Historic District Commission MEETING AGENDA

Monday, January 8, 2024 - 6:00 PM
Council Chambers, Easton Town Office
14 S Harrison Street

- 1) **Application Number:** 2020-367
Applicant: 128 S. West Street LLC
Location: 128 S. West Street
Tax Map 104, Grid 0EA, Parcel 1990
Zoning District: CB
Request: COA Extension for Previously Approved Addition.
- 2) **Application Number:** 2023-995
Applicant: Gant & Associates
Location: 31 S. Aurora Street
Tax Map 104, Grid 000, Parcel 1563
Zoning District: R-7A
Request: Exterior Alterations.
- 3) **Application Number:** 2023 - 1088
Applicant: John Peeling
Location: 208 Goldsborough Street
Tax Map 103, Grid 0EA, Parcel 1135
Zoning District: R-7A
Request: Renovation and New Construction.

Figure 1 Original right facade

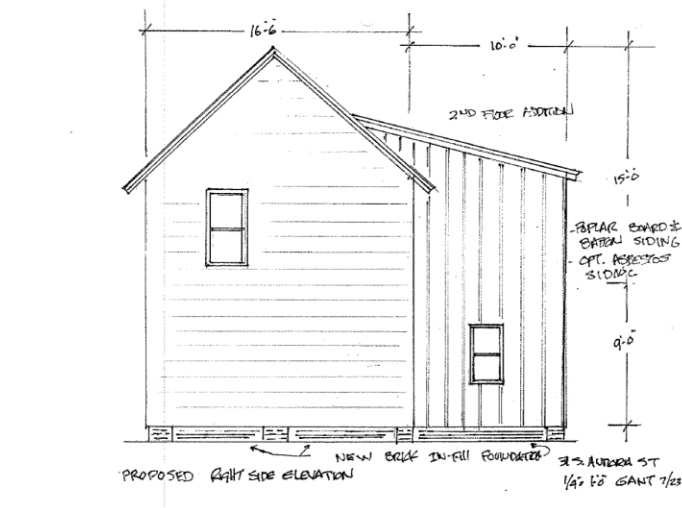
In August of 2023, the HDC approved renovations to the existing structure and the construction of a rear addition. The approved application showed the installation of one double hung window on the first story of the rear addition (Figure 1).

Rear entry door

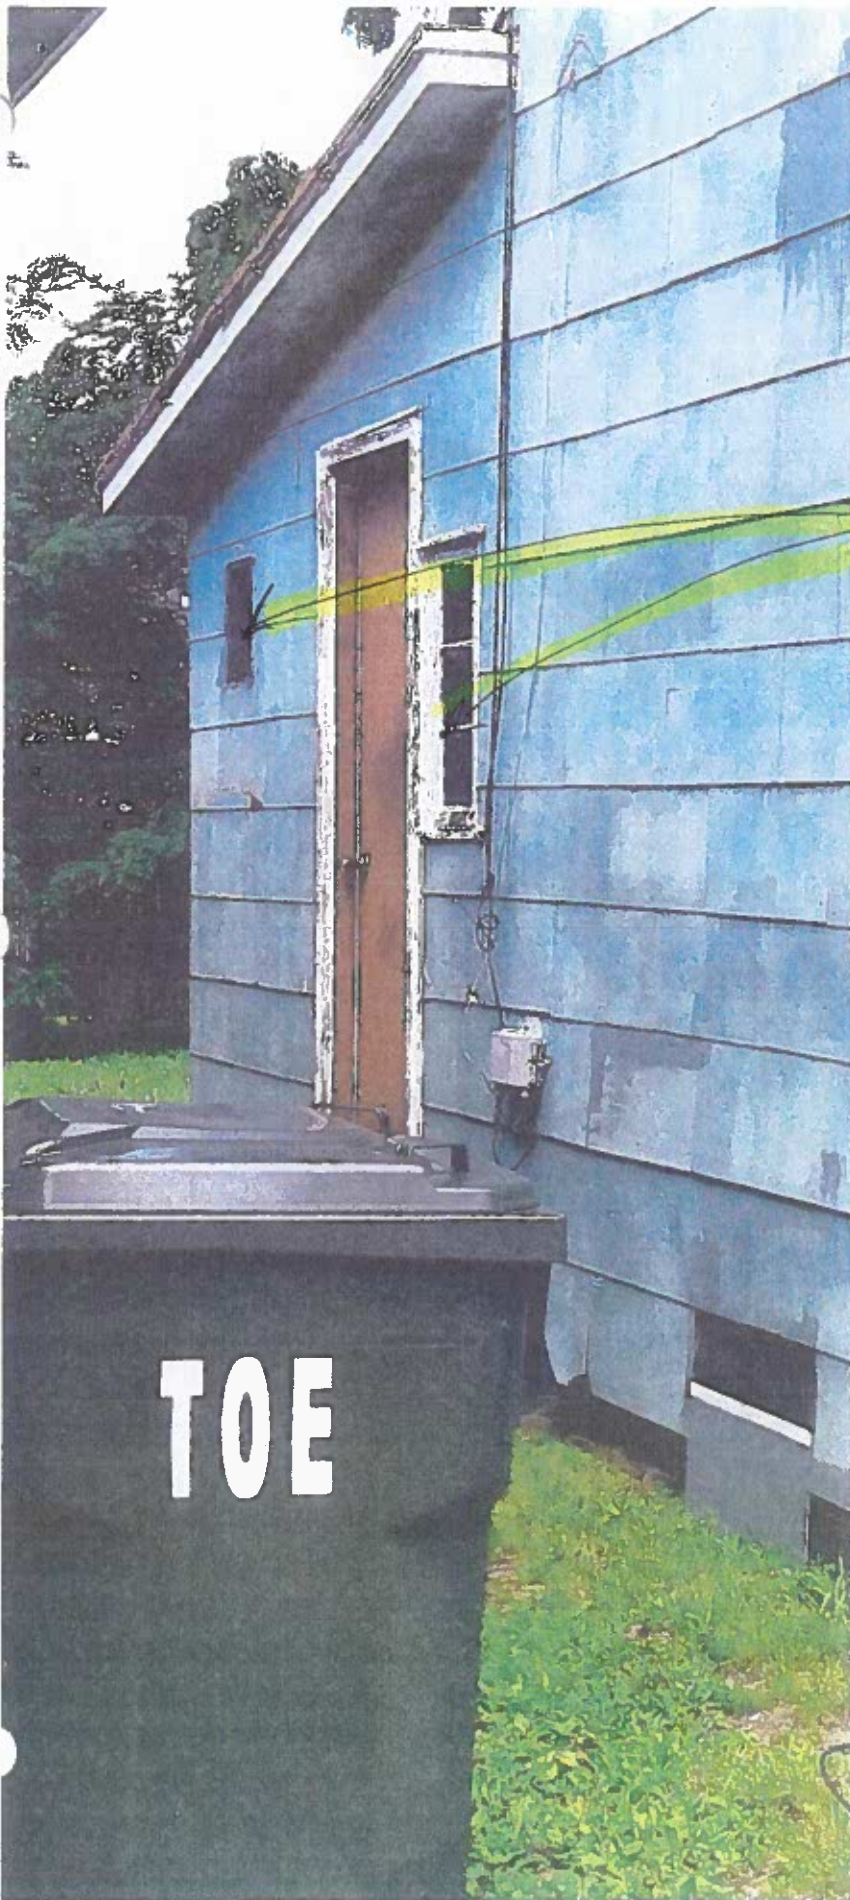
We have opted to use a full view glass door without grills instead of the previously approved door
None of the existing windows had grills

2. A cut sheet for the proposed rear entry door shall be provided to staff and reviewed by the Chair.

RIGHT SIDE ELEVATION

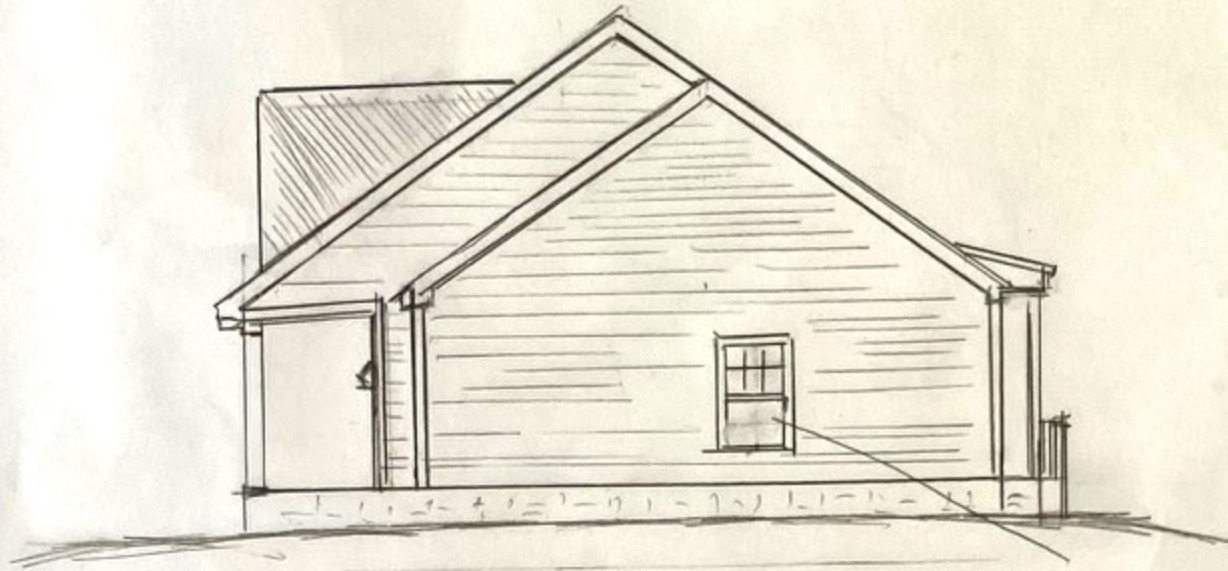
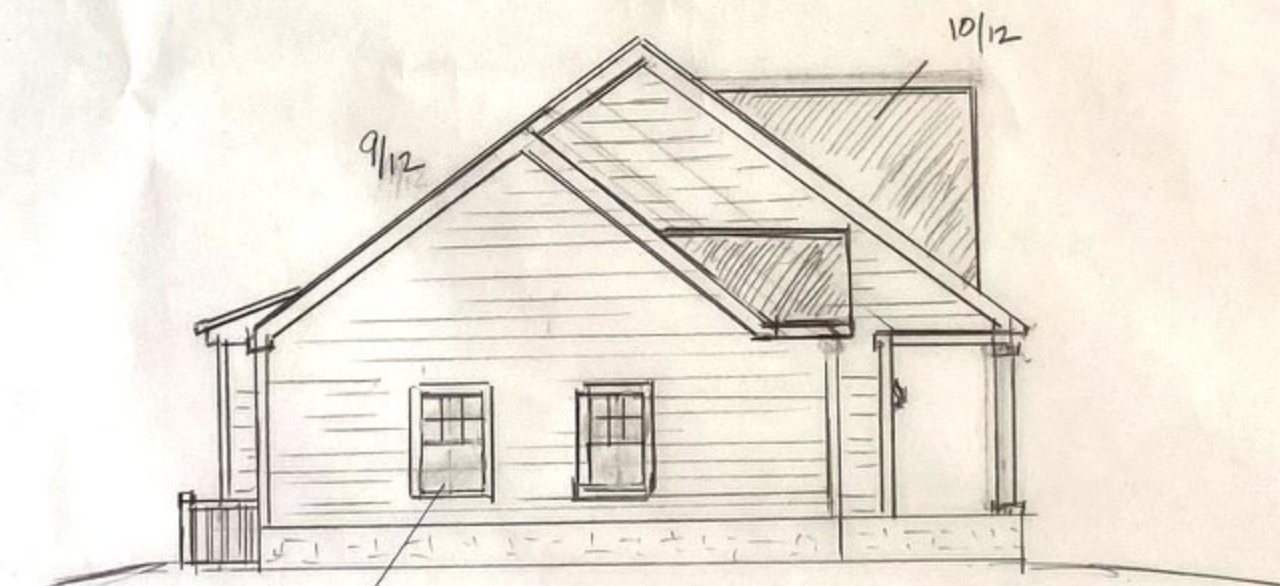
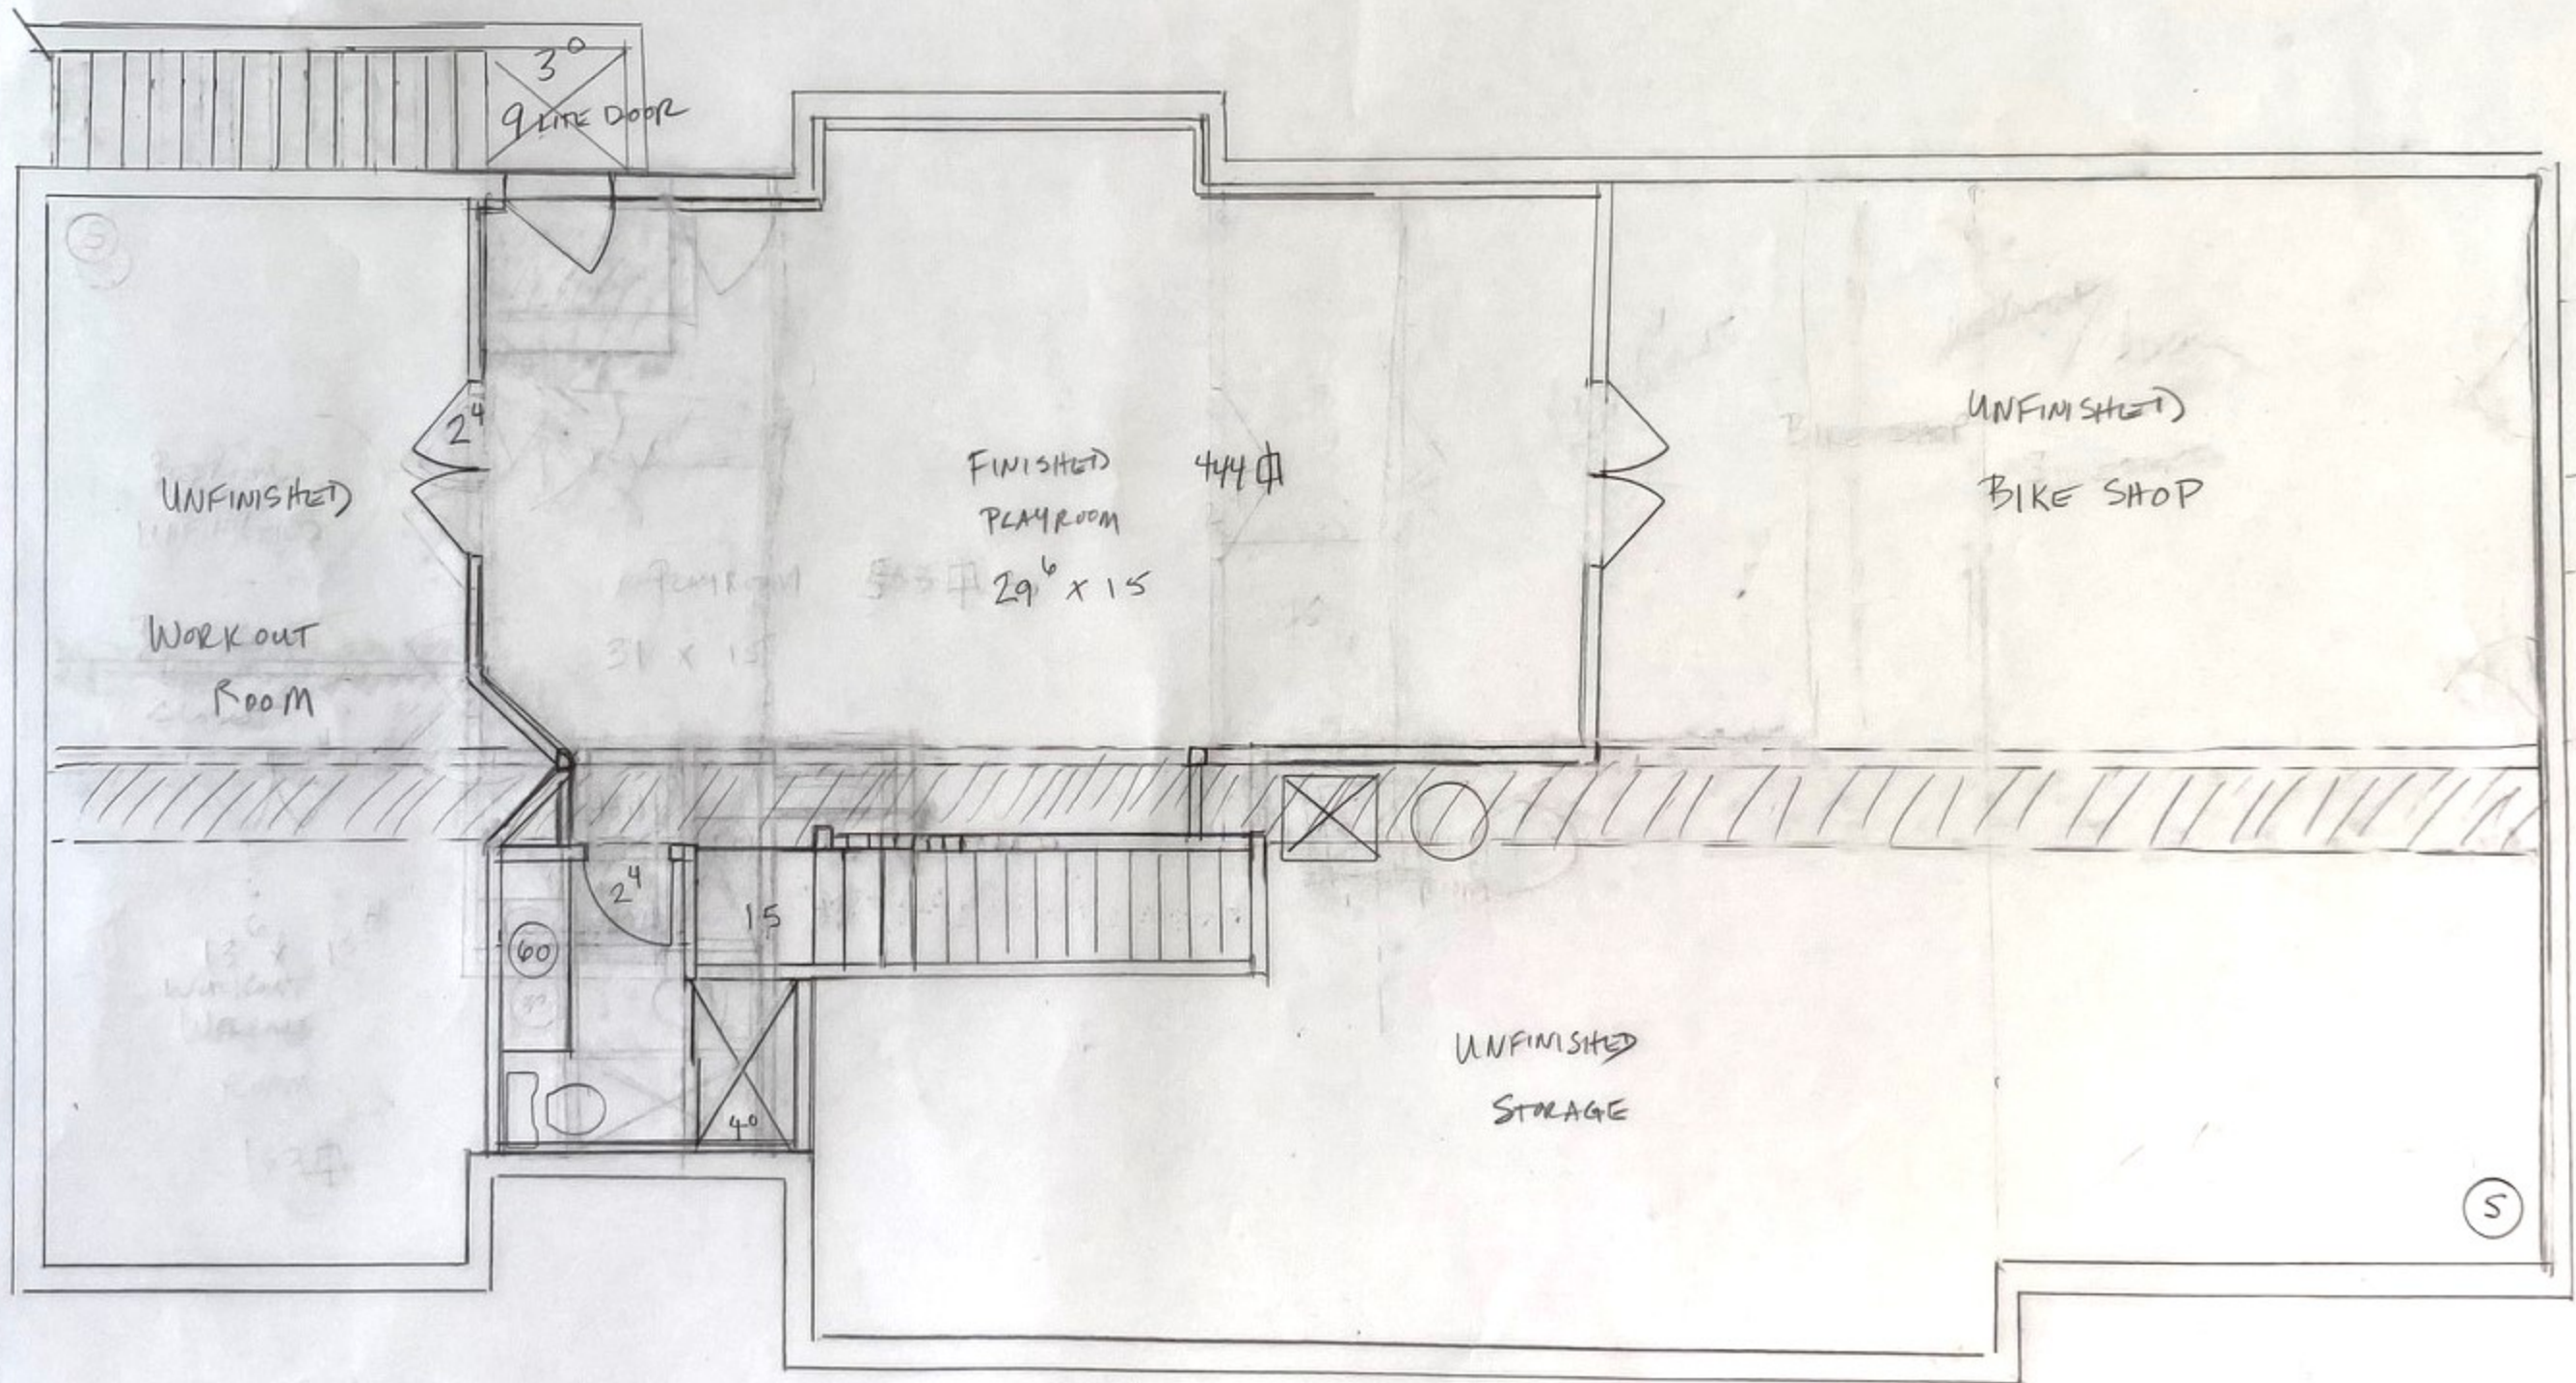
ANDERSEN
100 SERIES
W/GBG

ANDERSEN
100 SERIES
W/SDL

- 1. The applicant shall submit a cut sheet for the proposed standing metal roof to staff that meets the specifications of Guideline 70e.
- 2. All new SDL windows shall have three dimensional mutins.
